SUBJECT: NuScale Power, LLC Supplemental Response to NRC Request for Additional Information No. 28 (eRAI No. 8771) on the NuScale Design Certification Application

NuScale Supplemental Response to NRC Request for Additional Information eRAI No. 8771

15.0.06 Return to Power

Figure 15.0-19: RCS Flowrate (Peak Power Case EDSS Available)

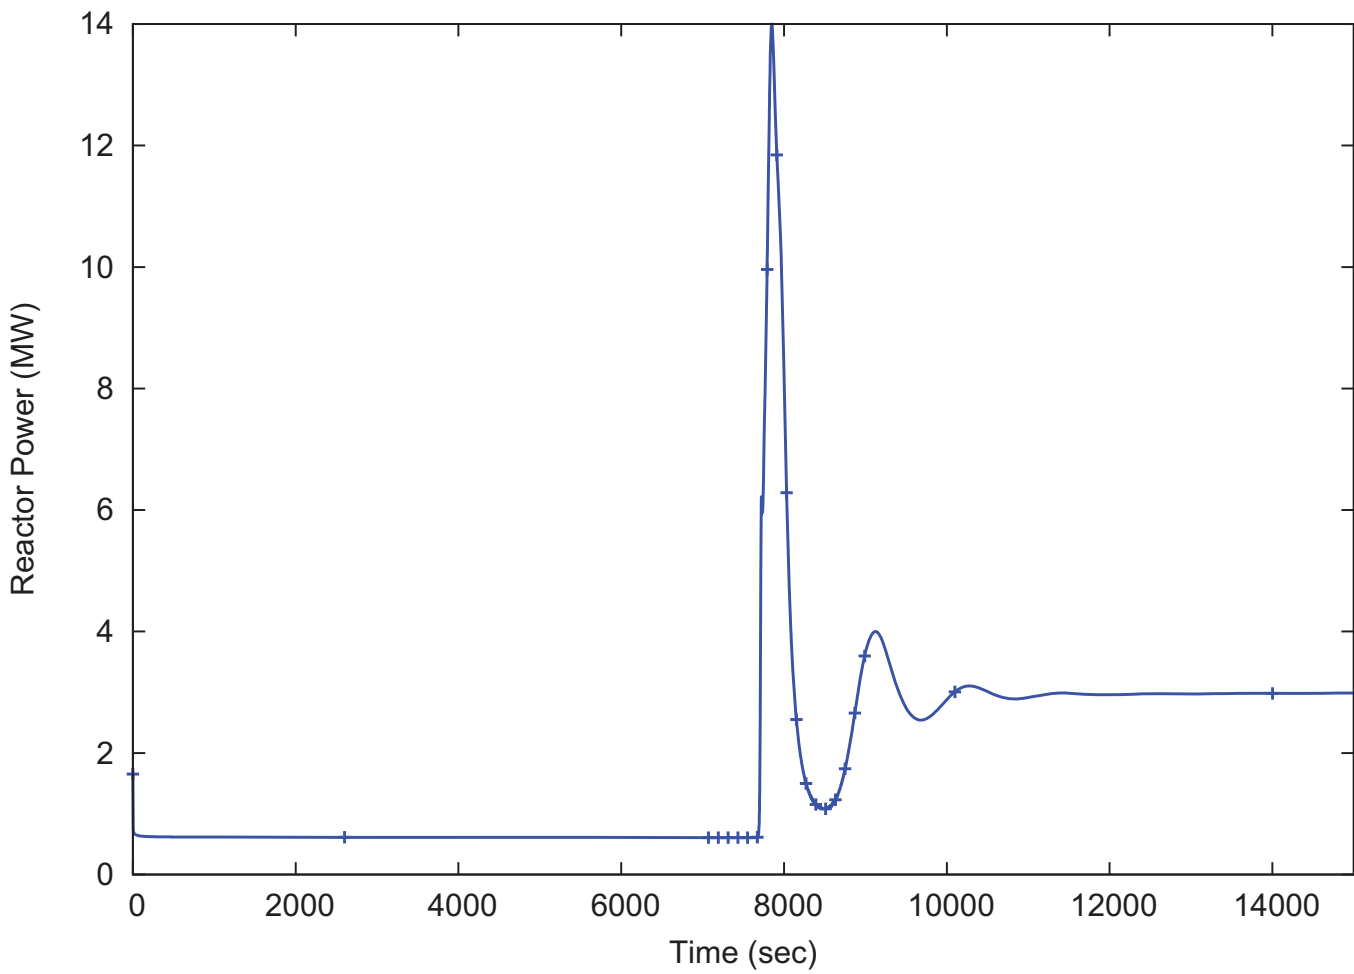
In order to provide additional clarification, additional wording has been added to FSAR Section 15.0.6 and two additional figures, Figure 15.0-18 peak power with EDSS available and Figure 15.0-19 for RCS flow with EDSS available have been incorporated.

RAI 15-1S1
